Barrel Warranty Recall Notification
27 AUGUST 2024

The difference between the extensions. The un-coated extension on the left is not affected in the recall. The black extension, on the right, is part of the recall depending on the date of manufacture.

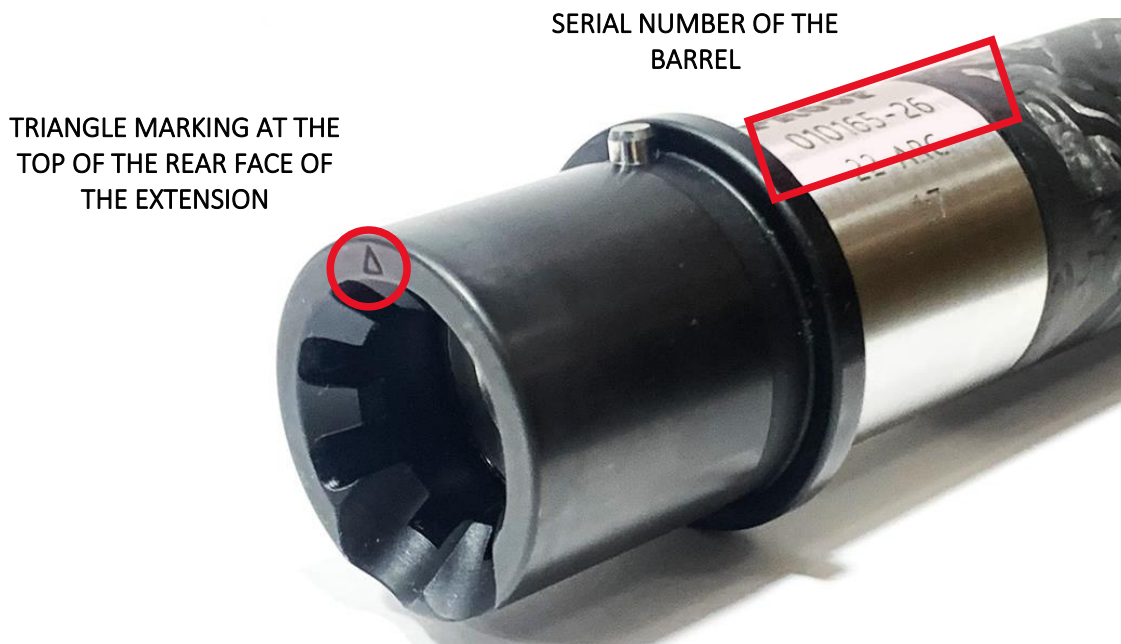
Proof Research is asking our customers to immediately discontinue use of and return certain 6 ARC and 22 ARC AR-15 barrels due to premature barrel extension wear that could lead to a potential safety hazard. These barrels are of recent manufacture and can be identified as having a black colored barrel extension with a triangular marking, Δ , at the top of the rear face of the extension. This warranty recall applies to all steel and carbon-wrapped AR-15 barrels of any length, chambered in 6 ARC or 22 ARC, and with the identified extension installed. These barrels were manufactured between end of January 2024 and August of 2024.

In several cases, barrels with cartridge feeding issues were brought to Proof's attention. These barrels have been returned to Proof Research and upon evaluation we have determined they can have premature extension wear and in extreme cases extension lug damage. Proof Research requests that all affected barrels be returned. Affected barrels will have a new extension installed, or at Proof Research's discretion the entire barrel assembly may be replaced.

To initiate the warranty recall process please email info@proofresearch.com or call Proof Research Customer Service at 406-756-9290. You will be asked to provide the serial number, engraved on your barrel(s). All shipment and upgrade costs will be covered by Proof Research.
